Planning and Amenity Delegated Committee Meeting

Tuesday 8 June 2021
at 6:30pm

Agenda

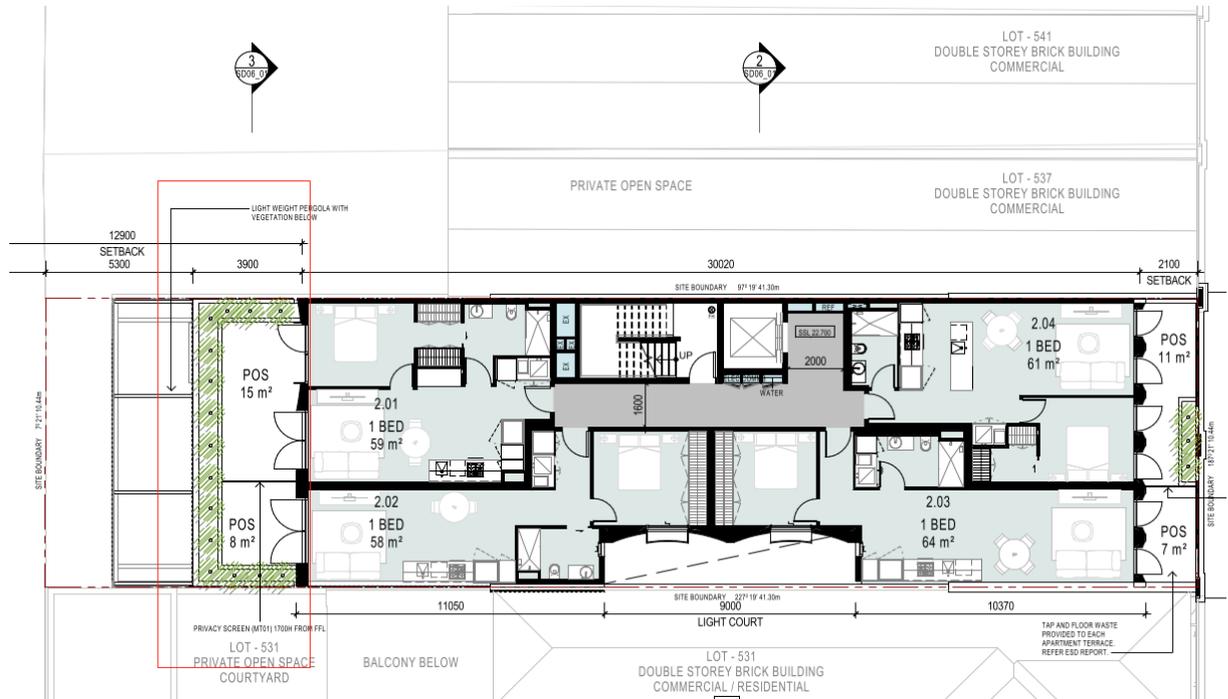
The proposed four storey does not minimise the impact on amenity particularly in terms of visual bulk and loss of outlook. The outlook from the dwellings to the west will be unreasonably impacted upon by the height and breadth of the proposed built form. A four storey building (15.92m) is very prominent, particularly in an area where the adjacent built form is lower. It is considered therefore that this building does not achieve an acceptable transition in scale to lower building forms in the residential precinct to the west.

Furthermore, the DDO12 requires where the site abuts the boundary of a property containing a dwelling and located in a Residential Zone the minimum setback from the title boundary of that property should be:

Figure 1: Highlighted first floor street setback non-compliance associated with Unit A.

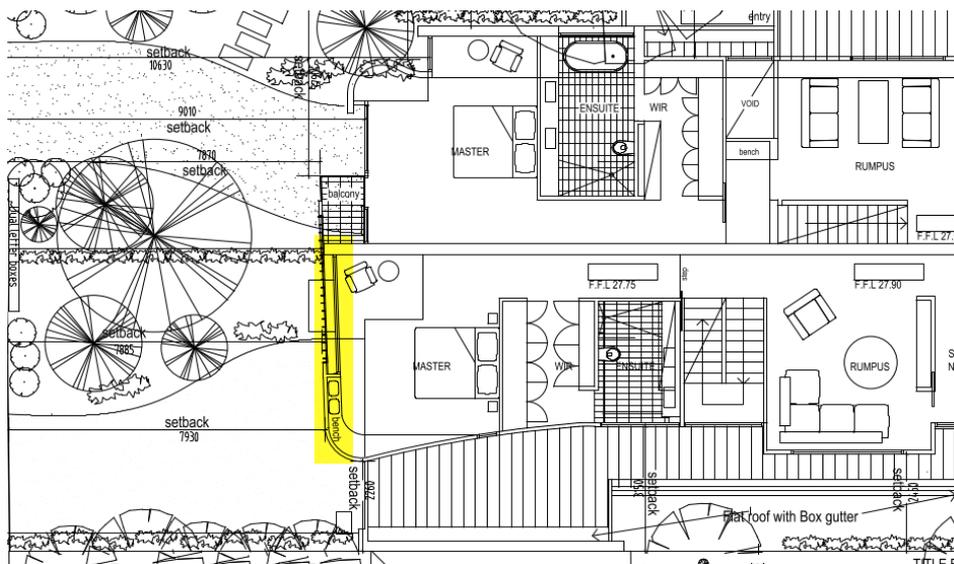
The northern first floor street setback associated with Unit A is non-compliant as shown highlighted in Figure 1 below. This is due to the design detail of the decorative wrap around screen which is considered to provide a reasonable level of articulation to the façade of the dwelling. The proposed design is consistent with the preferred character of the area and adopts a design which is site responsive. As such, the minor variation is supported.

The non-compliant areas are 7.88m – 7.93m from the street, a variation of 1.07m - 1.12m. This variation is acceptable as the non-compliant areas provide for an articulated and interesting façade to the streetscape. As noted above, the ground floor allows for adequate planting of vegetation. The existing street setback character of the area is varied with properties ranging from 6.1m – 9.2m. The adjoining northern property (111 Cromer Road) has a street setback of 7.6m, therefore the proposed first floor setback is acceptable as it provides for a transition to the adjoining property, see figure 2 below.

Figure 3: Area of non-compliant northern first floor setback highlighted.

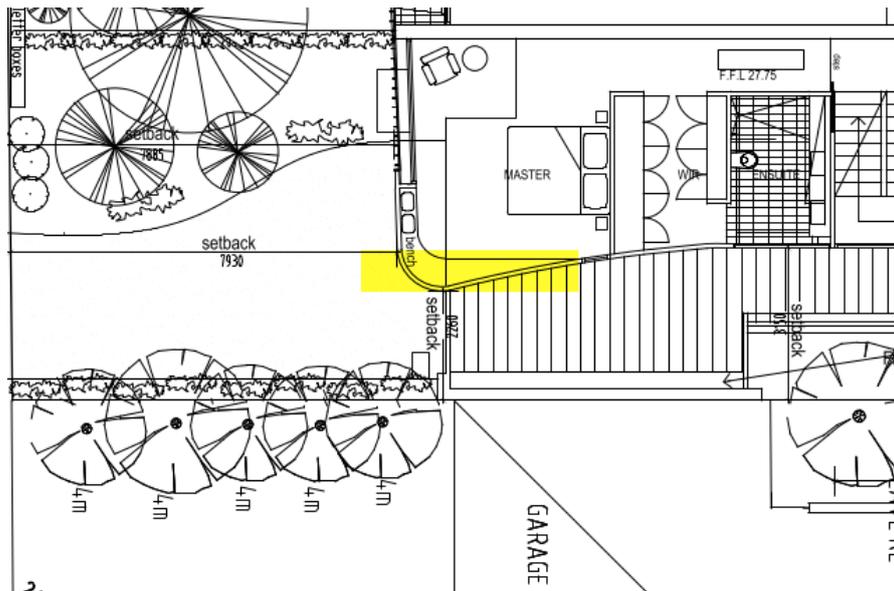
A small portion of approximately 1m of the first-floor northern side setback associated with the screen details of the master bedroom to Unit A is proposed to be 2.26m, where the standard requires 4.78m. A variation of 2.52m is supported as the area of non-compliance is minor (see figure 3 below) and is opposite the adjoining garage roof and driveway, therefore there are no unreasonable amenity impacts to the neighbouring property. The non-compliance also serves an interesting facade detail, articulating the front façade.

Figure 4: Area of non-compliant northern first floor setback highlighted.

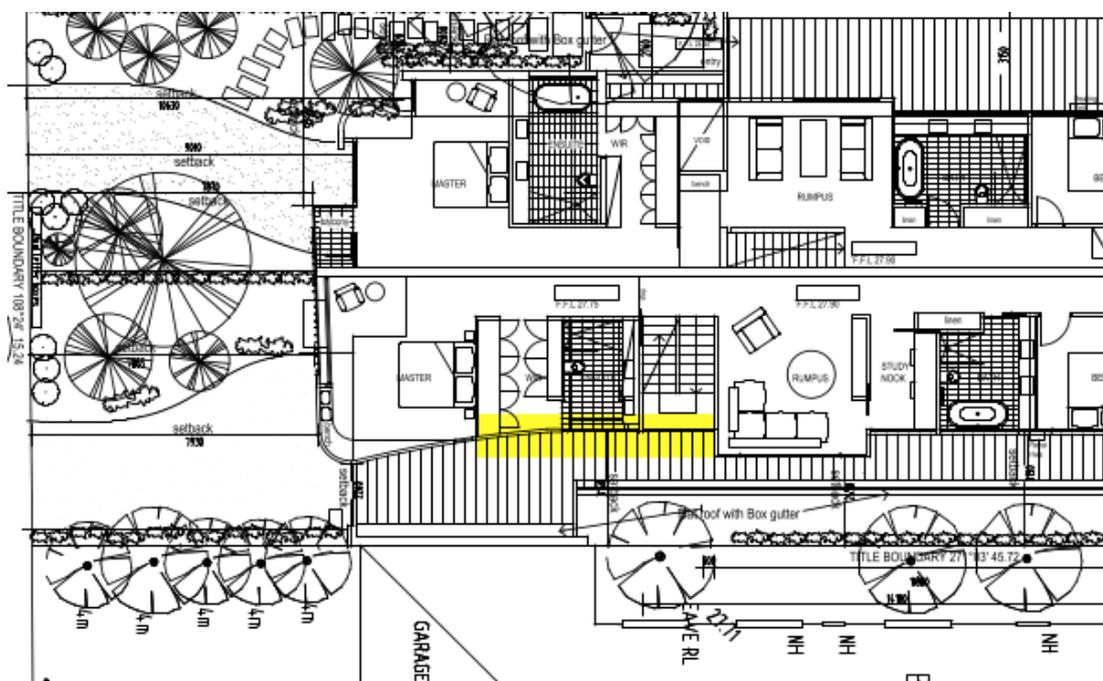
The first-floor northern side setback associated with Unit A’s en-suite, stairwell, study nook, bathroom, bed 2 and bed 3 is proposed to be 3.15m, where the standard requires 3.65m. A variation of 500mm is acceptable as the portion of non-compliance is adjacent to a side service yard associated with 111 Cromer Road, see figure 4 below. This area is a non-sensitive use area as the private open space is located to the rear of the dwelling and habitable room windows are located approximately 2.2m from the side boundary, resulting in the first floor walls of the proposal being setback 5.35m from the adjoining non - habitable room windows. This variation does not create any unreasonable off-site amenity impacts largely by way of overshadowing and overlooking, as these standards are both compliant.

Figure 5: Area of non-compliant northern first floor setback highlighted.

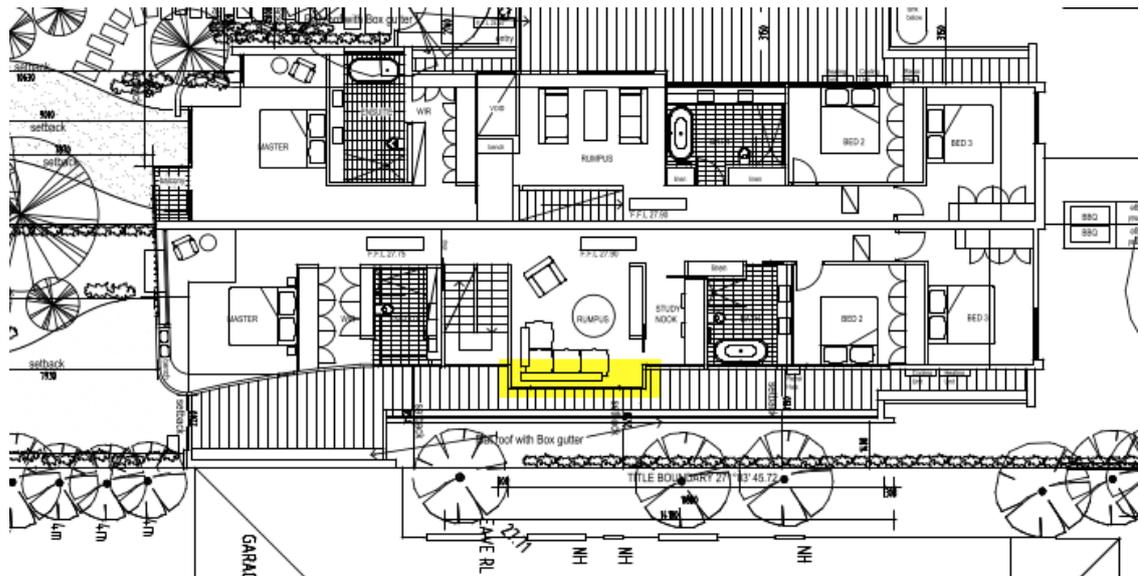
The first-floor northern side setback associated with the rumpus room to Unit A is proposed to be 2.45m, where the standard requires 3.65m, see figure 5 below. A condition has been included in the recommendation to setback the rumpus room to Unit A by 3.15m, to be in line with the remaining setbacks. This will work to minimise visual impacts to the adjoining property while maintaining a reasonable level of internal amenity

Figure 6: Area of non-compliant southern first floor setback highlighted

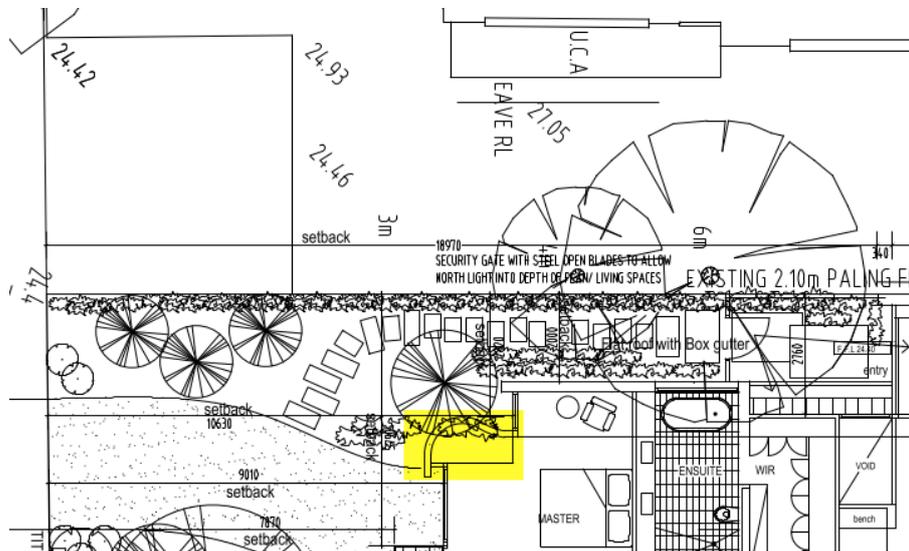
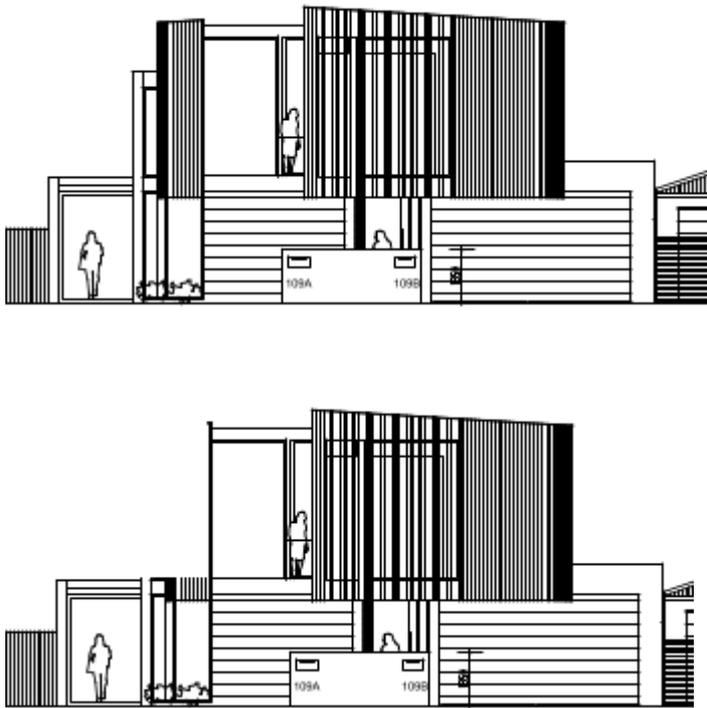
A portion of the first-floor southern side setback associated with the master bedroom to Unit B is proposed to be 2.82m, where the standard requires 4.23m. A variation of 1.41m is supported as the area of non-compliance is minor in size, see figure 6 below. The non-compliance also serves as an interesting facade detail, articulating the front façade. There are no unreasonable amenity impacts to the neighbouring property by a way of overshadowing or overlooking, as these standards are compliant. A fully compliant side setback of this portion may create an imbalance of the development and will result in a bulkier front façade by losing the timber screening detail, see imagine 6a below.

Figure 7: Area of non-compliant southern first floor setback highlighted

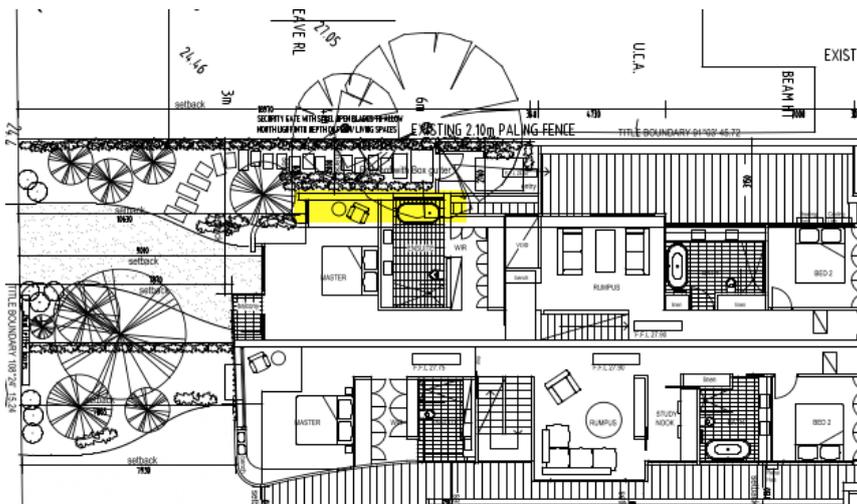
The first floor southern side setback associated with Unit B’s master bedroom and ensuite is setback 2m where the standard requires a setback of 3.26m. This wall has been lowered to reduce amenity impacts to the adjoining property however the wall is sheer from ground floor and is opposite the front garden/private open space area to the adjoining property (107 Cromer Road), see figure 7 below. A condition has been included to setback this portion of the wall a minimum of 2.82m from the southern boundary. A 2.82m side setback will align with the portion of the front facade that protrudes out to provide an articulated front façade, see figure 6. A fully compliant side setback at this area will not be seen from the street and would impact on the internal amenity of the dwelling.

Figure 8: Area of non-compliant southern first floor setback highlighted

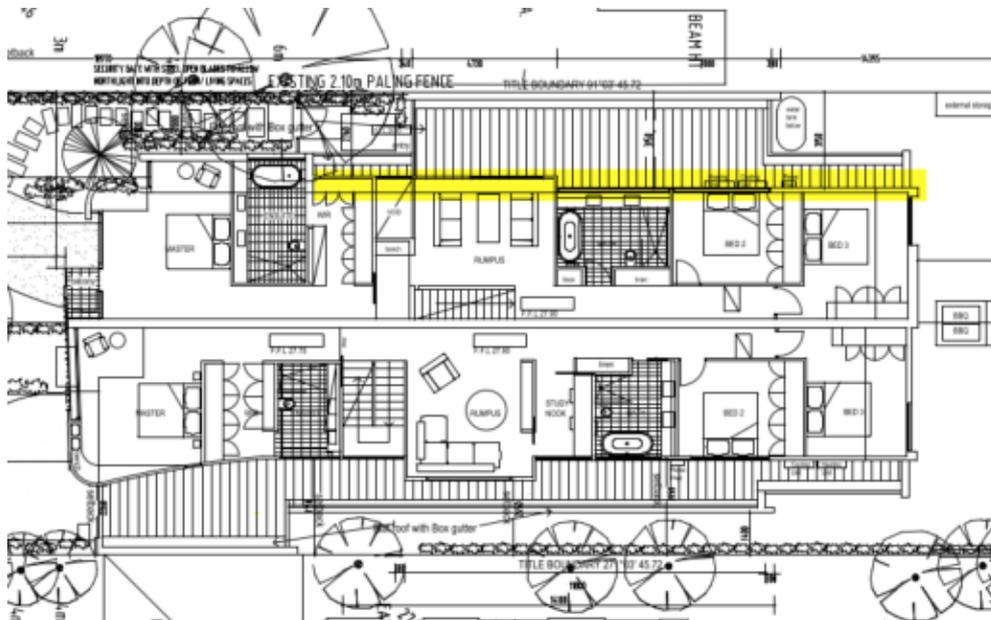
The first-floor southern side setback associated with Unit B’s WIR, void, rumpus, bathroom, bed 2 and bed 3 is proposed to be 2.76m-3.15m, where the standard requires 3.68m. A variation of 530mm is acceptable to the bathroom, bed 2 and bed 3 portion of

non-compliance, as this is adjacent to a covered roof area associated with 107 Cromer Road, see figure 8 below. This variation does not create any unreasonable off-site amenity impacts largely by way of overshadowing and overlooking, as these standards are both compliant.

A condition has been included requiring the non-compliant setback associated with the WIR, void and rumpus room to be setback 3.15m to be in line with the bathroom, bed 2 and bed 3 setbacks. This will reduce the visual bulk to the adjoining property.

Figure 1: First floor plan detailing highlighted areas of non-compliance

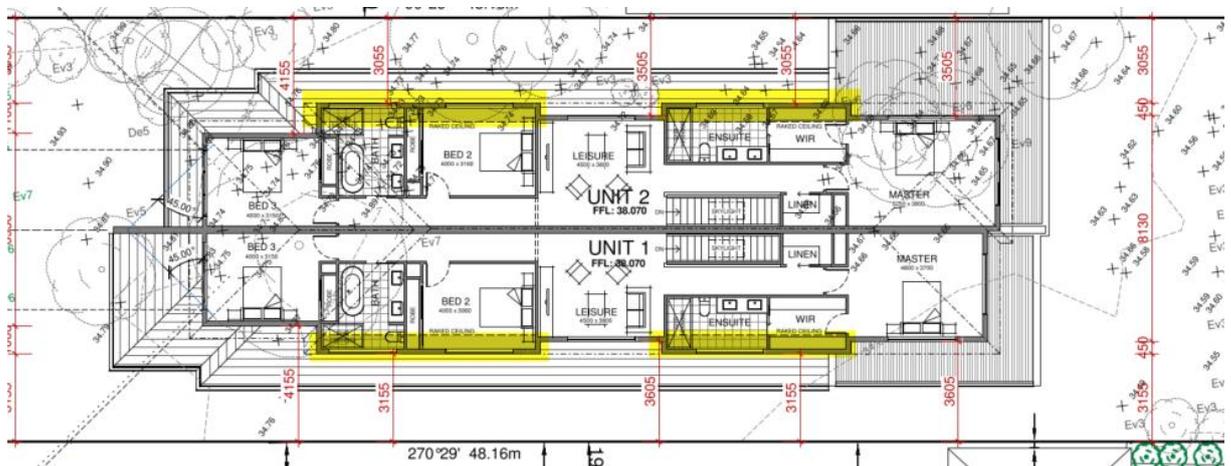
The front of the development facing the street includes compliant side setbacks, allowing adequate built form spacing and visual separation to the streetscape. All areas of non-compliance associated with both dwellings will provide for adequate articulation to the side of the dwelling, reducing bulk to the adjoining properties. Compliance with the side setback standard will result in one continuous line of built form, increasing the visual bulk of the development. See figure 1 below which highlights the areas of non-compliance.

Figure 1 – Ground floor kitchen side setback non-compliances (red).

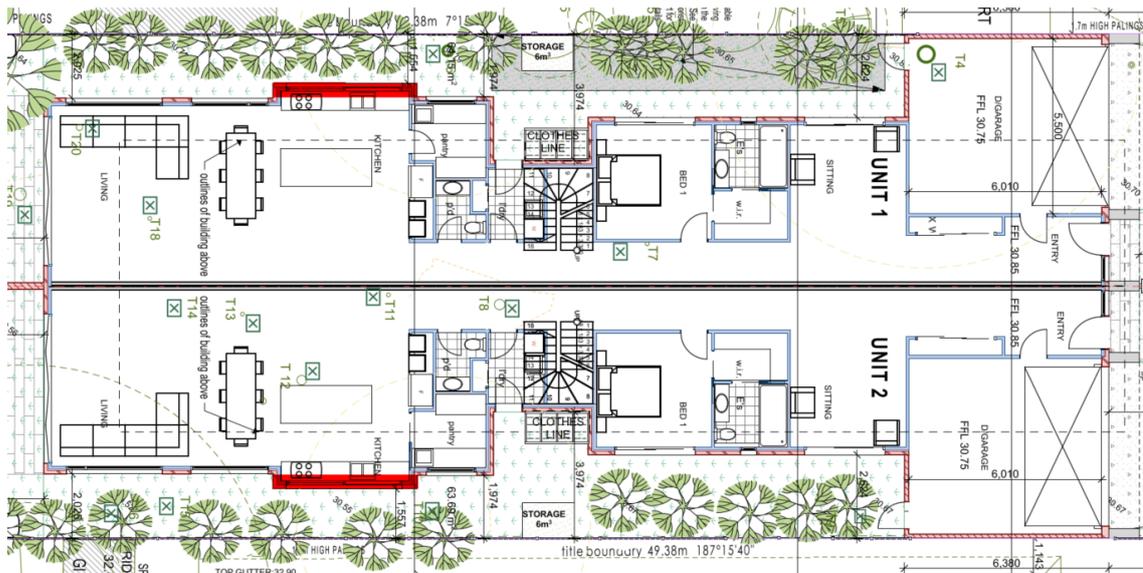
The objective of the standard is to ensure the height and setback of a building from a boundary respects the existing or preferred neighbourhood character and limits the impact on the amenity of existing dwellings. The ground floor kitchen walls of both dwellings do not comply with the side setback standard in relation to the side boundaries.
